Reconstruction to  
Plattekill Elementary School

Tt Project No. 17597-22002 – Phase 2B

BID Addendum No. 1  
to  
Drawings and Project Manual

October 21, 2024

Site Plan

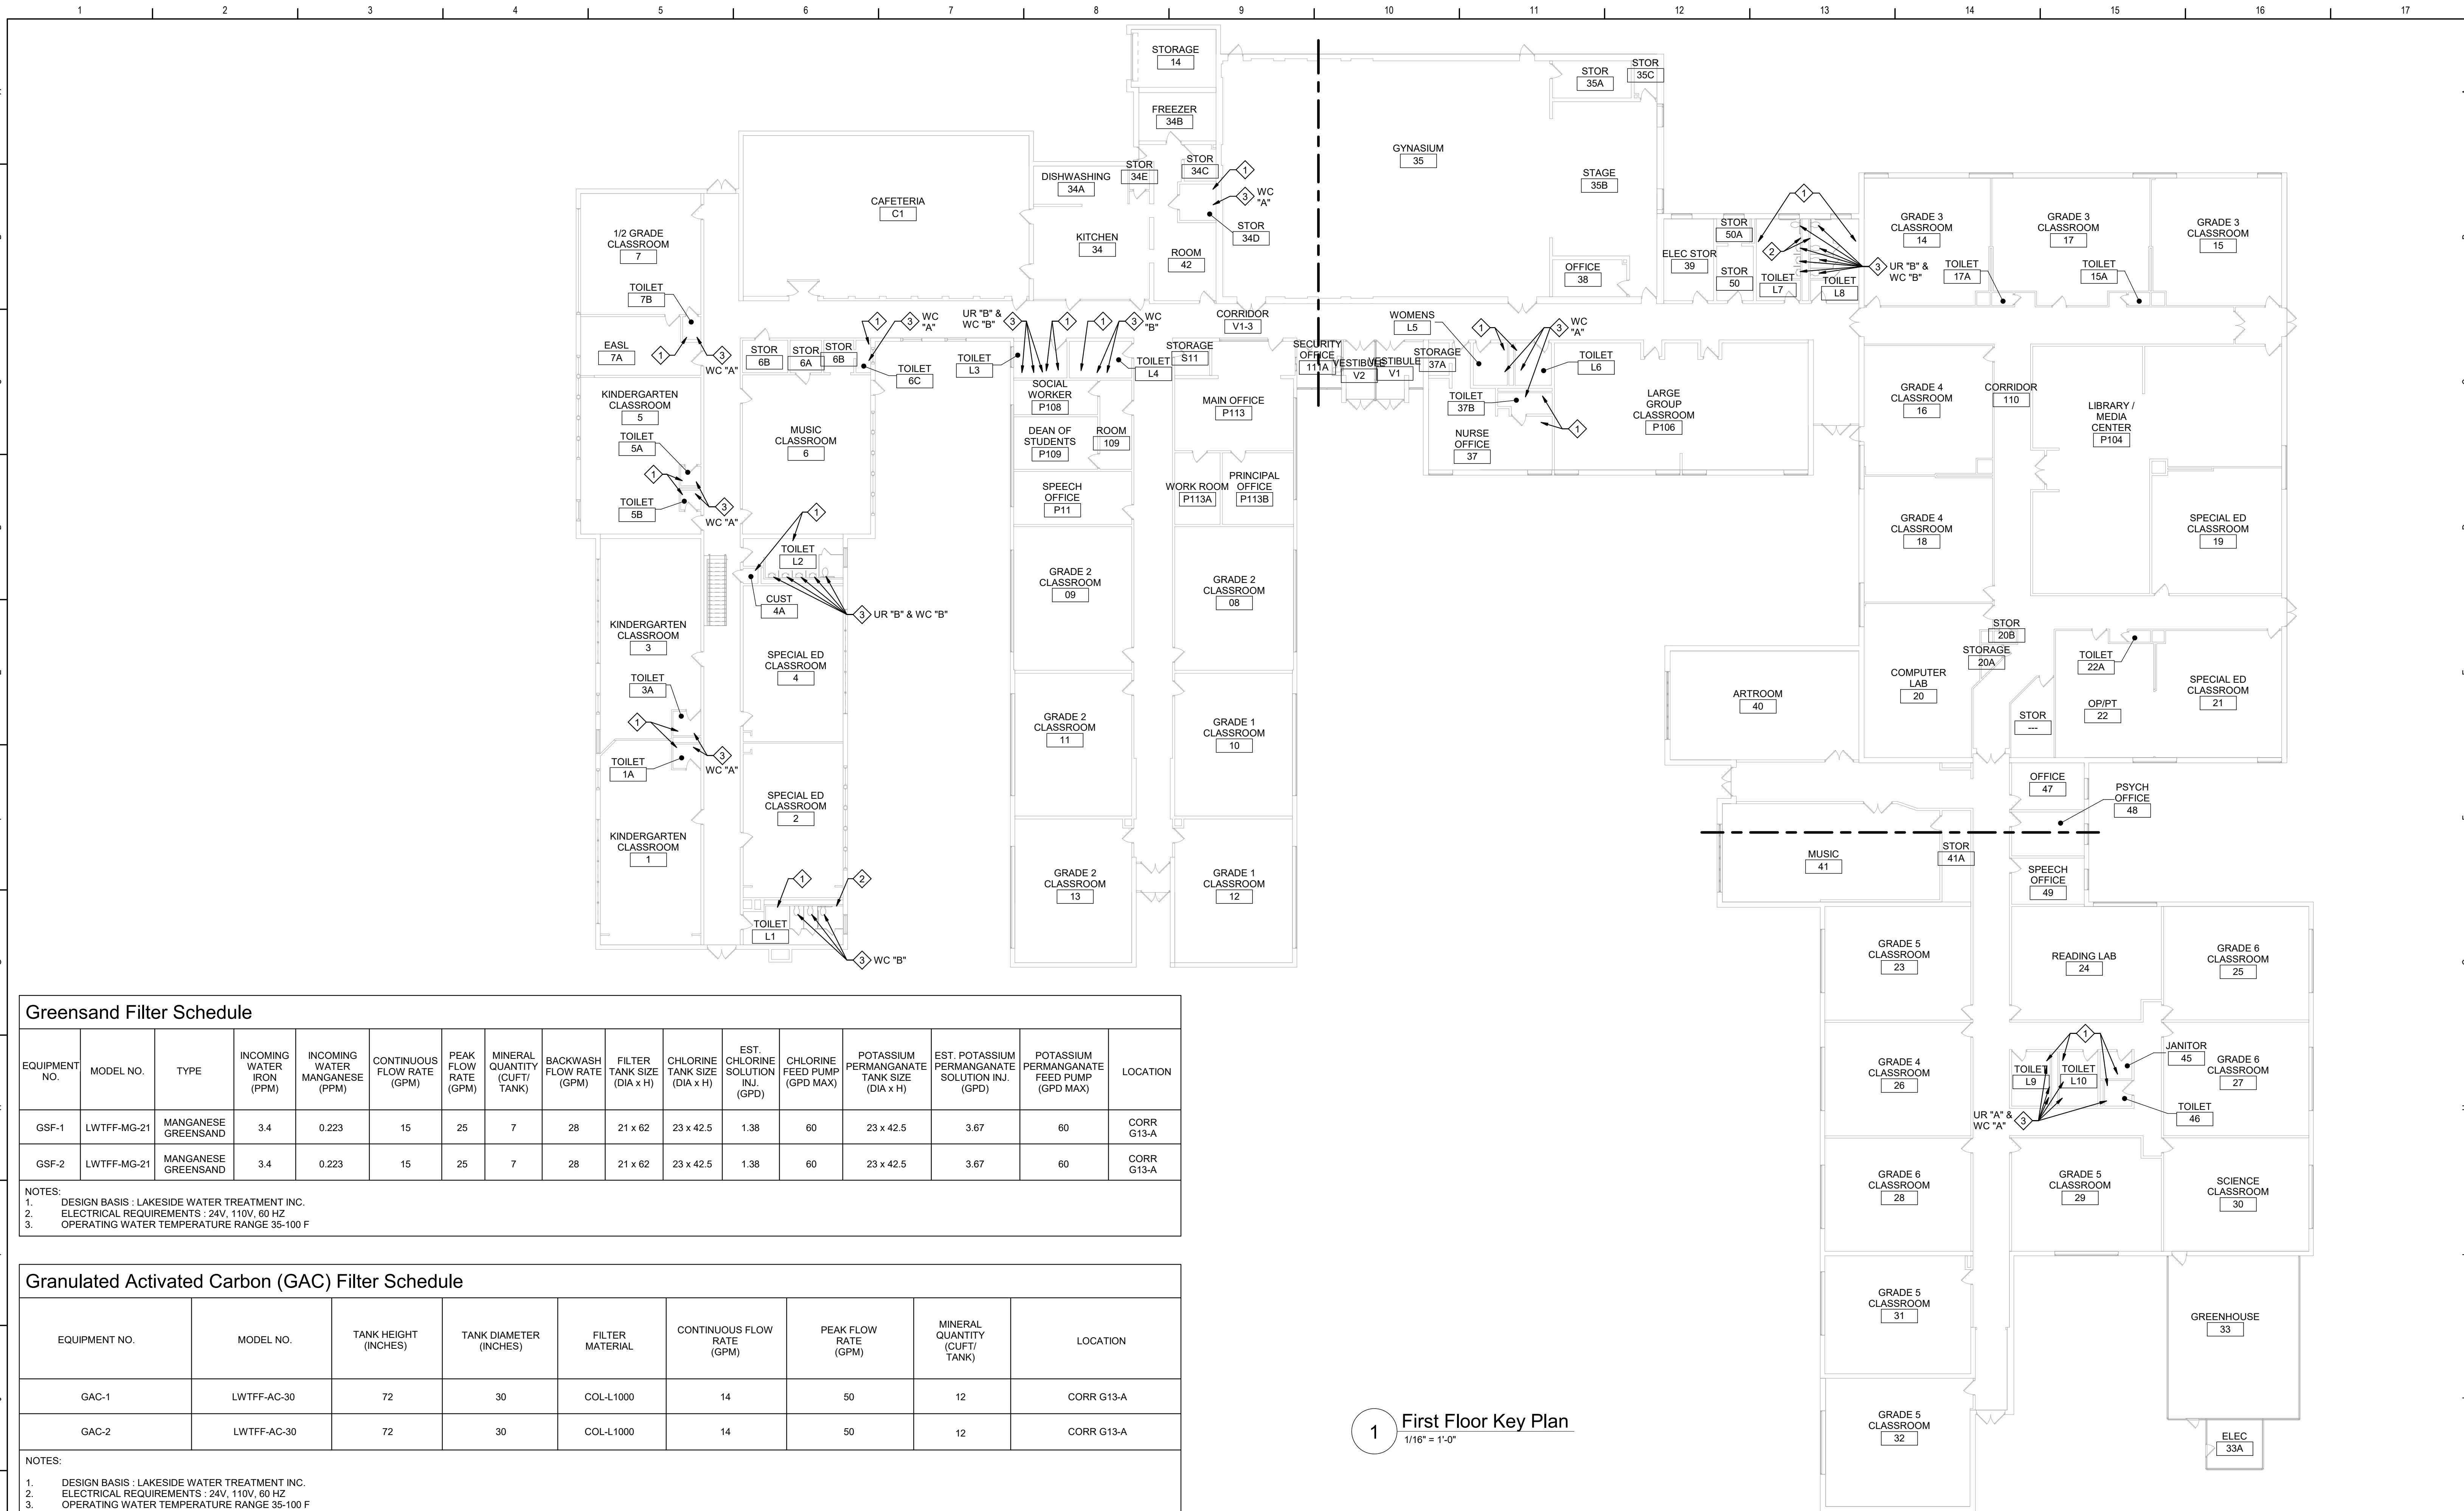
Also, will the PC provide all of its own site work for the exterior piping as shown on DP001, including trenching, backfilling, restoration, asphalt, etc.?

1. See Addendum No. 1 for further clarification.
  2. See Addendum No. 1 for further clarification.
  3. The project is a single prime contract. PC will be responsible for all proposed work including, but not limited to trenching, backfilling, restoration, asphalt, etc. PC may choose to hire a sub contractor to perform the aforementioned site elementats of the contract.
-

First Floor Key Plan, Detail and  
Schedules

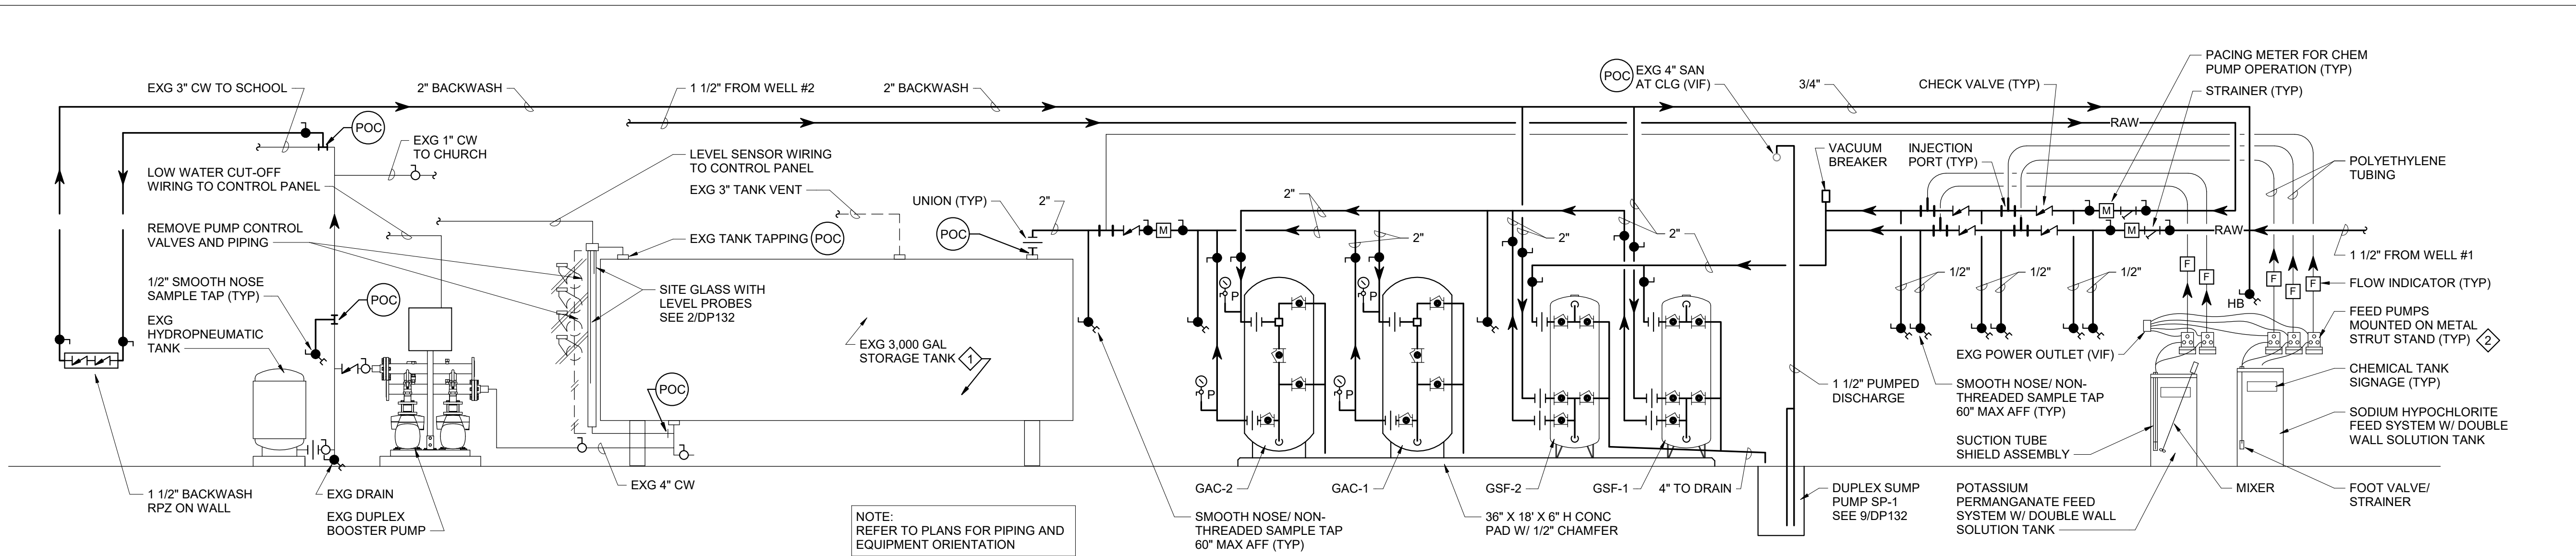
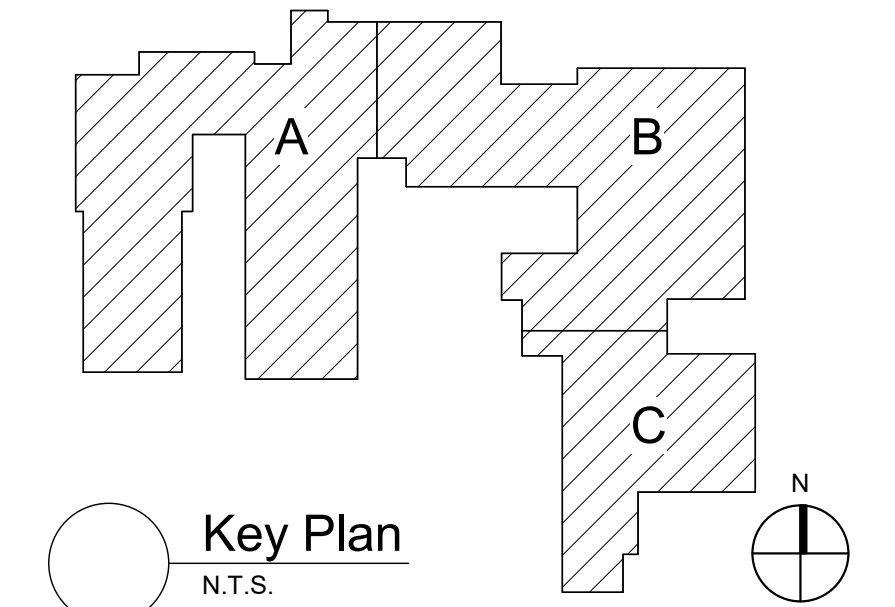
Also I don't see spec sections on the water treatment equipment (GAC, GSF) that is shown to be provided on DP130. Can you please provide those specs in an addendum?

Please refer to Bid Addendum No 1 for specification section 22 32 00 Domestic Water Filtration Equipment.
